ONTARIO ENERGY BOARD

AFFIDAVIT of Michael Leitch in the matter of OEB-2012-0458.

The K2 230Kv Underground Transmission Line

Exhibit C : K2's Proposed Cross Section of Underground Cable Installation

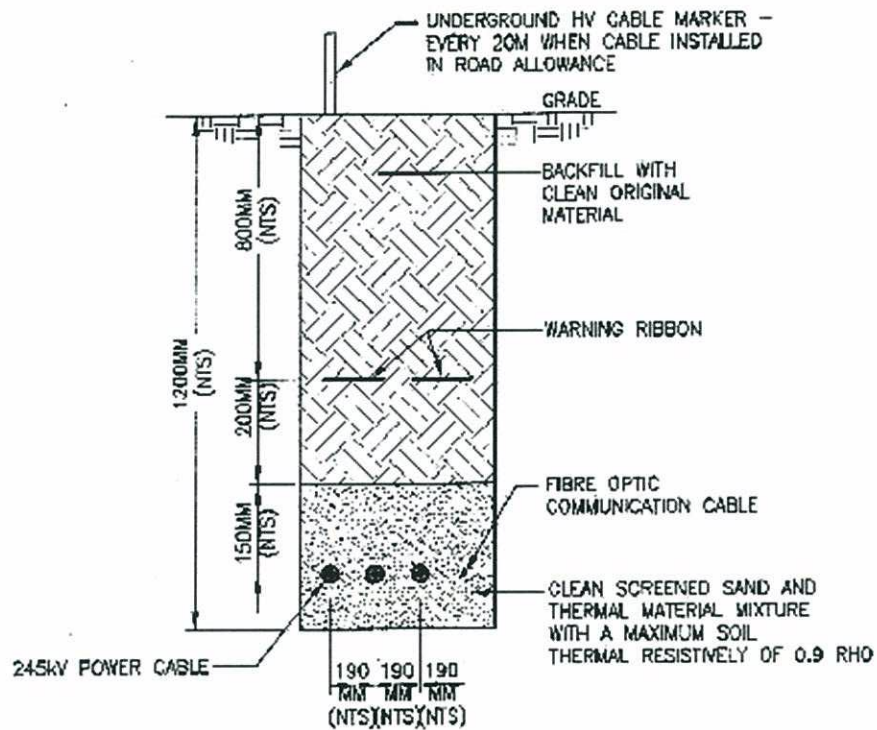
4. K2's 245Kv underground cable installation details show the 245Kv cable at a depth of 1200mm with a 190mm separation. The cables will be placed in crushed limestone and trench back filled with excavated native soil. A warning tape will be installed approximately 0.3m above the cables and will run the length of the underground cables. The K2 installation details do not provide for any additional mechanical protection. The cross sectional given is a distribution standard for voltages less than 69Kv. While this standard may work as a minimum for K2's 34.5KVv lines, I do not believe it will work for the 230Kv lines. Attached as Exhibit C to my affidavit is a copy of K2's Proposed Cross Section of Underground Cable Installation.

10. The high voltage cable that will be used by K2 is not something that can simply be buried a meter underground as proposed by K2. The cables will require more mechanical

protection to ensure that they are safe. The location for the planned 230Kv underground cable is a location where persons will be tilling land, cleaning out ditches, rebuilding roads, installing and repairing drainage tiles, installing fence posts and other utilities will be working on their underground plant.

17. My review of all the attached data, along with my conversations with the individuals identified in this affidavit, along with my own expertise in the field, lead me to the conclusion that K2 has not provided enough mechanical protection in its design for the 230Kv underground cable. Cables of this voltage require more than a warning tape. A red coloured cement barrier is at least a minimum requirement.

This is Exhibit "O " referred to in the Affidavit of Mike Leitch, Sworn Before me, on this ^{22ND} day of
 MARCH , 2013

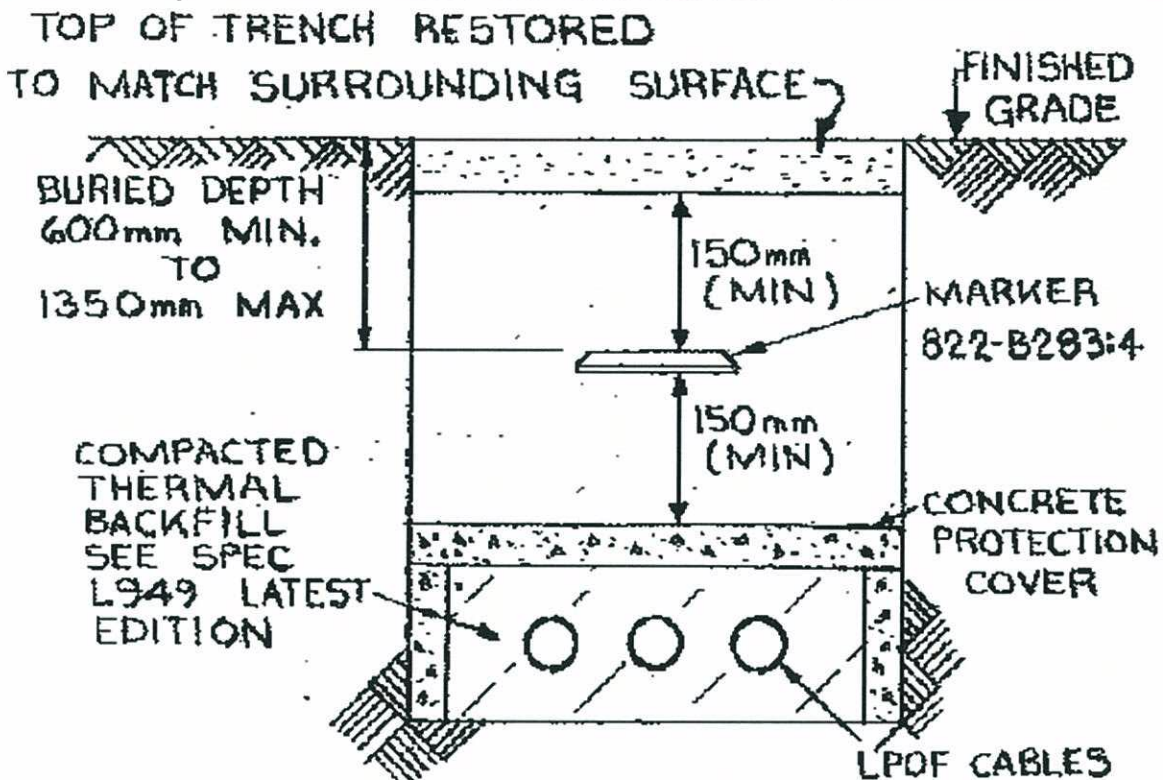
15. I have been advised by Badriath Comar, a Senior Design Specialist for Engineering Services Stations at Hydro One, and do verily believe that in accordance with the above standards that under no circumstances would 230Kv be installed without some sort of cement mechanical protection. Attached as Exhibit O to my affidavit is a copy of the Hydro One Cross Sectional of High Voltage Underground Trench.

Exhibit P: Dufferin Wind Power's Cross Sectional of 230kv Underground

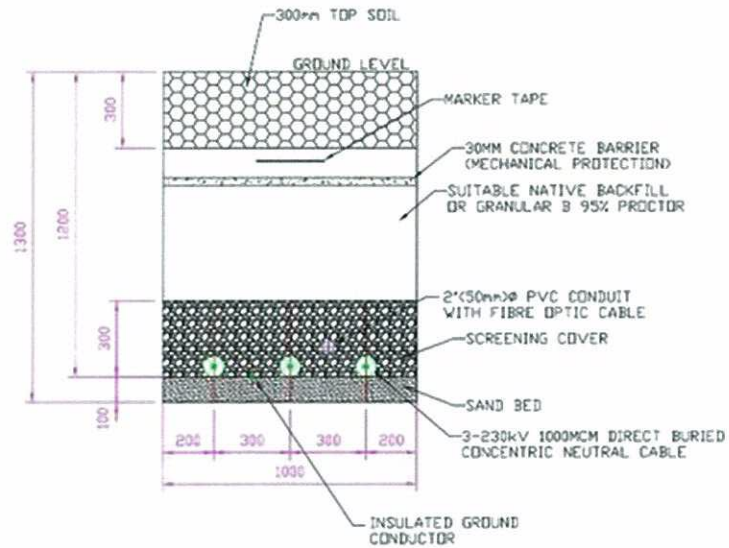
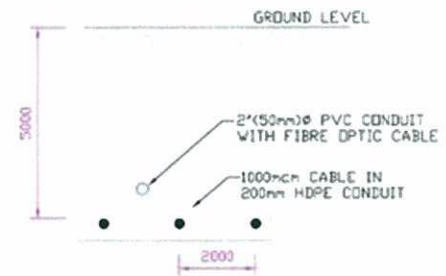
16. Dufferin Wind Power in their design for their proposed 230Kv underground line in the Shelbourne area show a 30mm concrete barrier for mechanical protection located below the marker tape in their typical 230Kv ductbank arrangement for direct burial. They also have a cross sectional for directional boring. It shows the ducts at 5000mm. Attached as Exhibit P to my affidavit is a copy of the Dufferin Wind Power’s Cross Sectional of 230Kv Underground Cable Proposed Direct Burial and Bored Cross Sections.
